UNITED STATES PATENT AND TRADEMARK OFFICE

| APPLICATION NO. | FILING DATE | FIRST NAMED INVENTOR | ATTORNEY DOCKET NO. | CONFIRMATION NO. |
|-----------------|-------------|----------------------|---------------------|------------------|
| 10/767,225 | 01/28/2004 | Yi-Lung Kuo | 23724-07838 | 2599 |

| Office Action Summary | Application No. | Applicant(s) | |

DETAILED ACTION

Lee et al., Figure 2

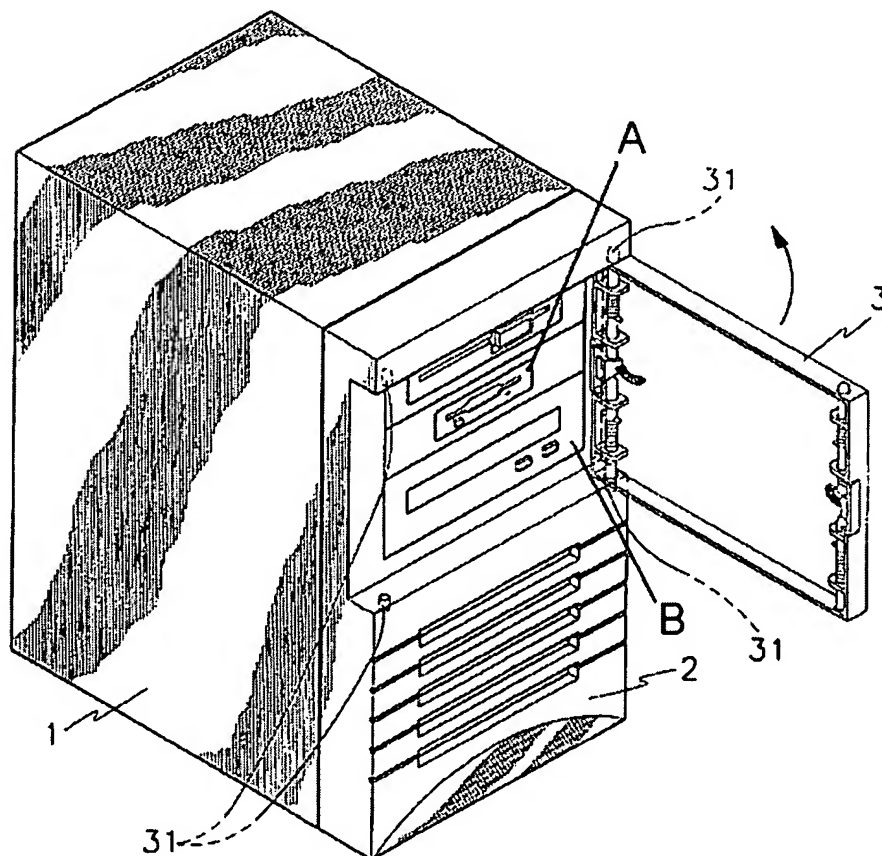
e. Regarding Claim 1, Lee et al. discloses a face plate apparatus for covering the drive and port interfaces of a computer, the apparatus comprising a cover plate (2) for concealing a plurality of interfaces for drives of different sizes of a computer while in a closed position, the cover plate having a window (see Lee et al., Column 2, line 57, “an open area of face 2”), a drive door (3) for covering the window in the cover plate through which a drive interface can be accessed while the cover plate is in a closed position and a mechanism (see Lee et al., Column 4, line 51-52, “said face being attached to a front portion of said case” Although Lee et al. does not describe the mechanism, it is clear that there is a mechanism present to secure the face to the case.) for securing the cover plate to a computer chassis.

- g. Regarding Claim 4, Lee et al. discloses that the drive door (3) is substantially opaque (best seen in Lee et al., Figure 1. The fact that the drives aren't visible through the door indicates that the door is opaque as defined in Webster's New Riverside Dictionary: "impervious to the passage of light").
- h. Regarding Claim 5, Lee et al. discloses that the plurality of interfaces comprise an interface for a 3 ½-inch drive (A) and an interface for a 5 ¼-inch drive (B).

- i. Regarding Claim 6, Lee et al. discloses that the drive door, while in a closed position, is configured to conceal an interface for a 5 ¼-inch drive (B).
7. Claims 1 and 2 are rejected under 35 U.S.C. 102(b) as being anticipated by Lan et al. in US Patent 5116261.

Lan et al., Figure 2

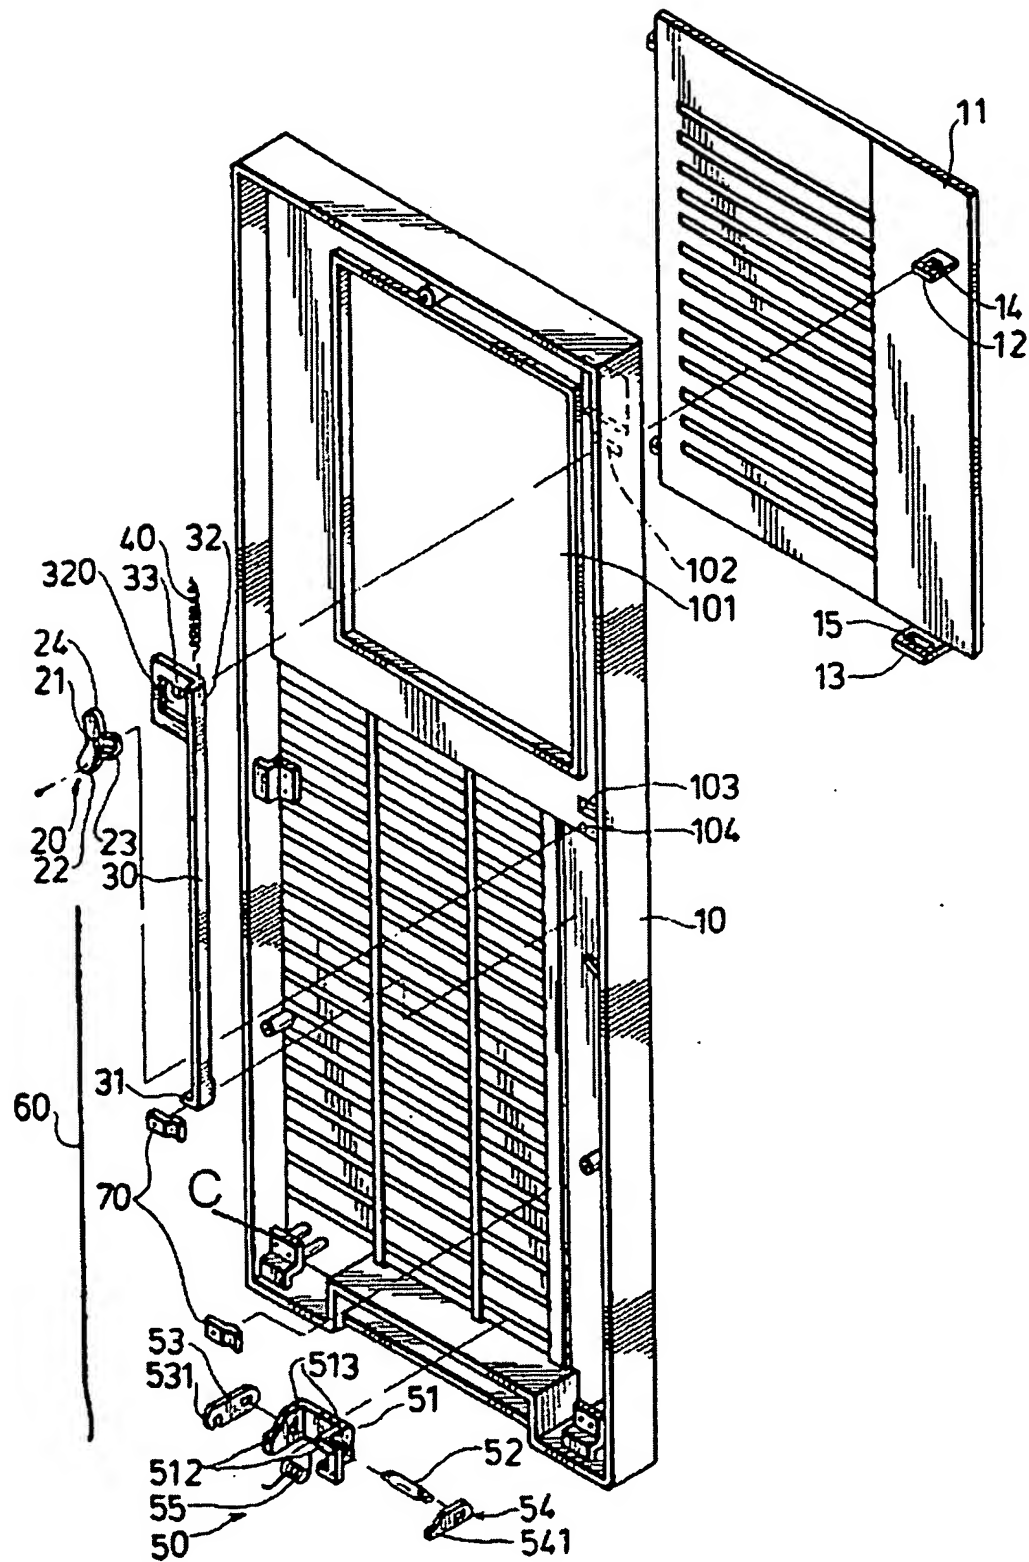
j. Regarding Claim 1, Lan et al. discloses a face plate apparatus for covering the drive and port interfaces of a computer, the apparatus comprising a cover plate (10) for concealing a plurality of interfaces for drives of different sizes of a computer while in a closed position, the cover plate having a window (101), a drive door (11) for covering the window in the cover plate through which a drive interface can be accessed while the cover plate is in a closed position and a mechanism (C) for securing the cover plate to a computer chassis.

k. Regarding Claim 2, Lan et al. discloses that the computer chassis comprises a "small form factor computer chassis" insofar as it is described by the applicant.
